Access Compliance Report

Public Rights-of-Way

(Curb Ramps)

Intersection ID: 43847	Main Street: BRADSTREET COMMONS WY	Cross Street: ROTHMAN LN	Location: S
ADA ID: E10D7832DBE2	Ramp Type: PerpDiag	Initial Pass/Fail: Pass	Overall Compliance: No
Severity Score: 12.75			
Codes/Mitigation Info/Possible Solution		Field Measurements/Component Compliance

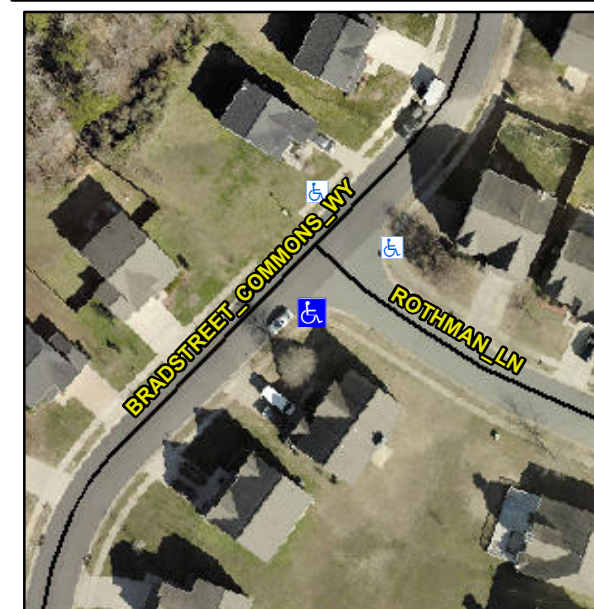
Not Found, R304.5.3, R304.2.1, R304.2.2-Perp, R304.3.2-Para, R302.7.2, R304.5.4

Compliance	Description	Data	Compliance	Description	Data
N/A	Ramp Length (in)	48.0	Yes	Ramp Slope (%)	7.6
Yes	Ramp Width (in)	48.0	No	Ramp XSlope (%)	4.0
N/A	Flare Type LT	Sloped	N/A	Flare Type RT	N/A
N/A	Flare Slope LT (%)	6.3	N/A	Flare Slope RT (%)	0.9
N/A	Flare Traversable LT?	No	N/A	Flare Traversable RT?	No
No	Landing Length (in)	47.0	Yes	DWS Provided?	Yes
Yes	Landing Width (in)	48.0	Yes	DWS Contrast?	Yes
No	Landing Slope (%)	2.1	Yes	DWS Length (in)	24.0
No	Landing X Slope (%)	3.3	Yes	DWS Full Width?	Yes
N/A	Landing Curb? (Y/N)	No	Yes	DWS Offset (in)	1.0
N/A	Shared Landing?	No			
Yes	Gutter Ponding?	No	No	Gutter Slope (%)	5.8
No	Gutter Lip Ht (in)	0.5	No	Gutter X Slope (%)	3.0
N/A	Painted X Walk1?	No	N/A	Painted X Walk2?	No
	X Walk 1 Direction	To NE		X Walk 2 Direction	To NW
N/A	X Walk 1 Width (in)	N/A	N/A	X Walk 2 Width (in)	N/A
	X Walk 1 Slope (%)	2.7		X Walk 2 Slope (%)	1.5
	X Walk 1 X Slope (%)	1.1		X Walk 2 X Slope (%)	0.5

N/A	Ramp inside XWalk1?	N/A	N/A	Ramp inside XWalk2?	N/A
	Road Slope (%)	1.4	N/A	Clear Space?	Yes
	Road X Slope (%)	1.1	N/A	Clear Space to XWalk (in)	N/A
Yes	Any Obstructions?	No	Yes	Storm Grate/Utility Hazard?	No
	Obstruction Type			Storm Grate/Utility Type	
		N/A			N/A
			Yes	Surface Condition? (G/P)	Good

Remove & Replace Curb Ramp With Two New Directional Ramps or Equivalent. Remove & Replace Gutter.
